Application No. 10/083,760  
Amendment dated June 8, 2004  
Reply to Office Action dated April 27, 2004

**Amendments to the Drawings:**

**REMARKS**

Fig.2

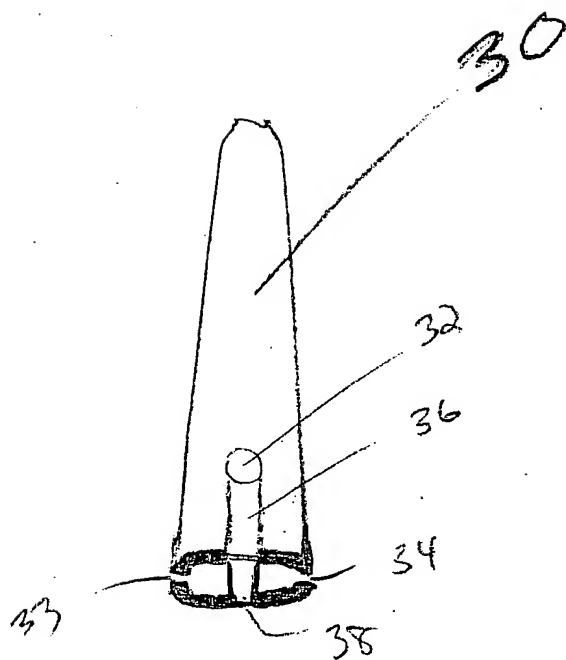
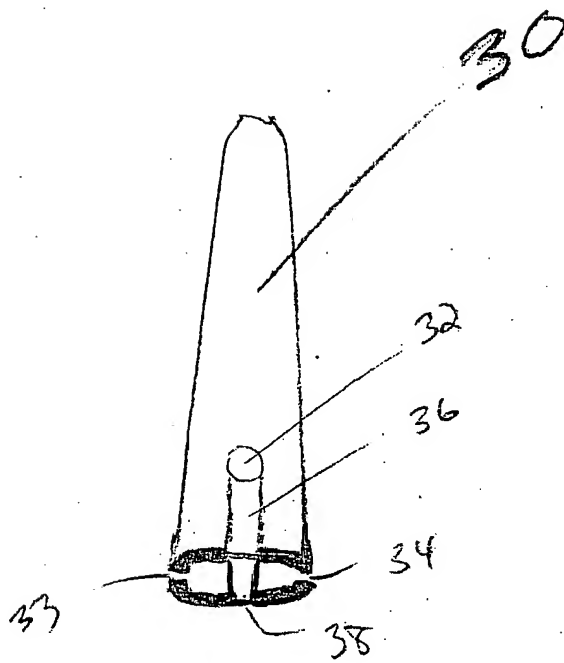
In paragraph 2 of the Office Action, the Examiner has objected to the drawings under 37 CFR 1.83(a) because the rivet head channel is not shown in the drawings.

Upon review of Fig. 2, rivet back channel 38, although partially illustrated, is not shown in full. Rivet back channel 38 as described on page 6, paragraph [0015] of the specification, is similar to rivet head channel 36 except that it is located on the back side of cover 30.

As shown in Fig. 2, the reduced thickness at the open end of cover 30 is shown for rivet head channel 38, but the rest of the channel extending up towards the closed end of cover 30 was inadvertently not shown. As such, Applicant has amended Fig. 2 to show rivet back channel 38 extending away from the open end of cover 30 towards the closed end of cover 30, until it disappears behind the top of cover 30. This amendment Fig. 2 more clearly illustrates the element as described and more closely corresponds to the other rendition of rivet back channel 38 shown in Fig. 4.

The attached sheet of drawings includes changes to Figs. 2 and 4, which appear on drawing sheets 2 and 4 respectively. These sheets 2 and 4 replace the original sheets 2 and 4. In Fig. 2, the element 38 has been completely shown. In Fig. 4, the element identifier "22" has been added.

Applicant respectfully disagrees with this assertion. The rivet head channel 36 is described in detail on page 6, paragraph [0014] of the specification:

This feature of a rivet head channel is shown in Fig. 2, properly identified as

element 36, where a channel is shown extending from the open end of the cover to the rivet head receiving slot 32. Additionally, the angled front view of figure 2 shows the open end of cover 30 having a first thickness and the rivet head channel 36 having a second lesser thickness. The rivet head channel is also illustrated in different views in both Figs. 3 and 4.

Fig. 4

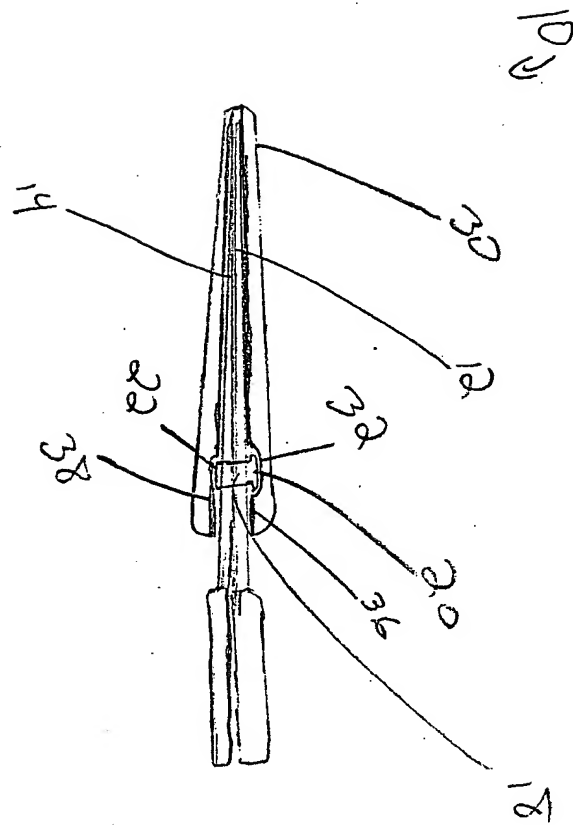
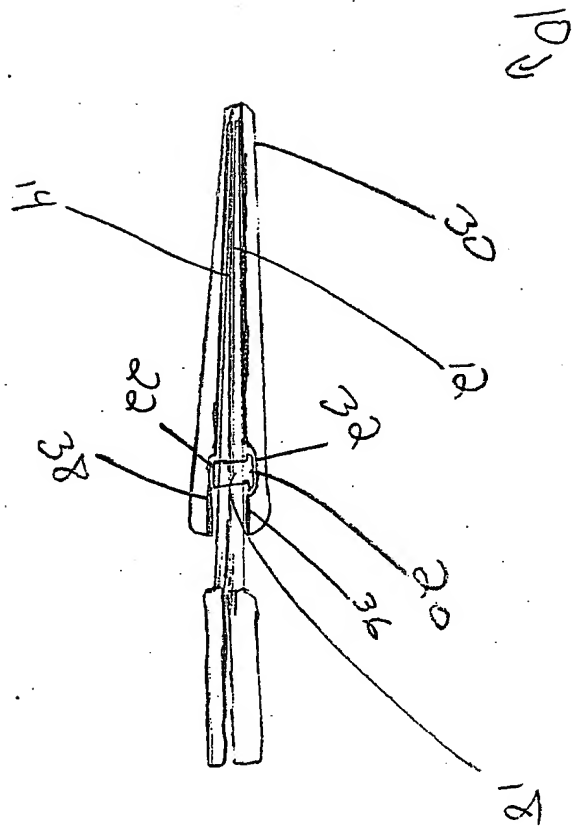
In paragraph 1 of the Office Action, the Examiner has objected to the specification because the element identifier "22", on page 5 is missing from the drawings. Applicant has amended paragraph [0011] of the specification to indicate that element 22 is illustrated in Fig. 4, and the corresponding element identifier "22" has been added to Fig. 4. As such, Applicant respectfully requests that the objection to the specification be withdrawn.
